UNITED STATES PATENT AND TRADEMARK OFFICE

| APPLICATION NO. | FILING DATE | FIRST NAMED INVENTOR | ATTORNEY DOCKET NO. | CONFIRMATION NO. |
|-----------------------|-------------|----------------------|---------------------|------------------|
| 10/809,138 | 03/25/2004 | Paul Jeffrey Garnett | 5681-88700 | 7727 |

Office Action Summary

DETAILED ACTION

Fig. 3A

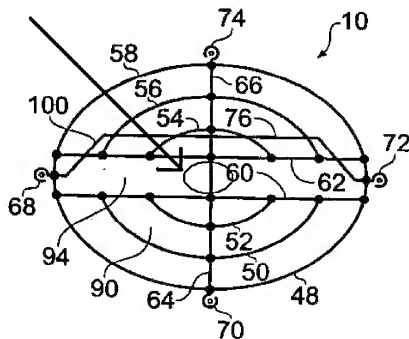
Please note that none of the figures show an opening configured to receive a handle as claimed. All of the figures with the exception of figures 4 and 5 show an obstruction (strut, loop or partial loop) that would prevent an opening from receiving a handle as claimed. It is noted in figures 4 and 5 that even though no obstruction is shown that an obstruction is part of the construction as evidenced by page 11, lines 12-15.

For the purposes of examination, only figure 3A of the instant application is considered. The examiner assumes that the portion of the strut circled above is shown in error since omission of this portion will allow similar grills to be stacked upon one another as claimed.

2. The drawings are objected to under 37 CFR 1.83(a). The drawings must show every feature of the invention specified in the claims. Therefore, the opening configured to receive a handle must be shown or the feature(s) canceled from the claim(s). No new matter should be entered.

Figures 6 and 7 of US Patent Number 5,490,452 (Schlosser et al. hereinafter)

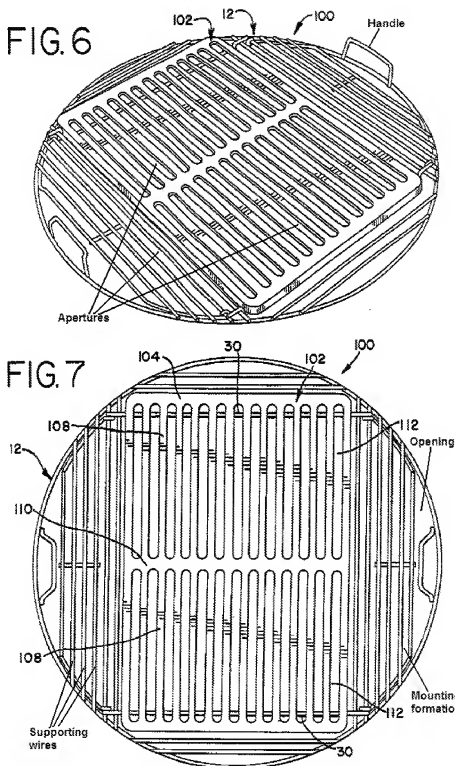
5. Claims 1-4, 8, 11, 17, 18, 20, 34 and 35 are rejected under 35 U.S.C. 102(b) as being anticipated by US Patent Number 5,490,452 (Schlosser et al. hereinafter).

6. In re claim 1 Schlosser et al. discloses

wherein the substantially planar portion of the grill (100) comprises an opening capable of receiving a handle of a substantially similar grill (100) when stacked on top of the substantially similar grill (100) such that the substantially planar portions of the stacked grills (100) are substantially parallel when the grills (100) are stacked;

the grill of Claim 1, wherein said substantially planar portion comprises at least one shaped wire arranged to form a loop (12) or partial loop.

FIG. 2

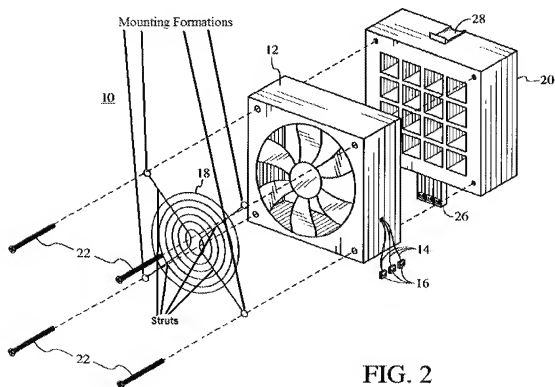
27. Bull et al. teaches at least one mounting formation (see Fig. 2 of Bull et al.) comprising shaped wire extending away from a substantially planar portion (18) and arranged to form a loop or partial loop (see Fig. 1 and Fig. 2 of Bull et al.).

30. Bull et al. teaches at least one mounting formation for mounting the grill on a fan or fan housing wherein at least one mounting formation and strut are integrally formed from a piece of shaped wire (see Fig. 1 and Fig. 2 of Bull et al.).

36. Bull et al. teaches wherein the section of wire shaped to provide support and at least one mounting formation are formed from a common section of wire (Fig. 2 of Bull et al.).

39. Bull et al. teaches further sections of wire shaped to form further loops or partial loops arranged in said common plane (Fig. 2 of Bull et al.).

42. Bull et al. teaches further sections of wire arranged to provide further support for the at least one loop or partial loop (Fig. 2 of Bull et al.).
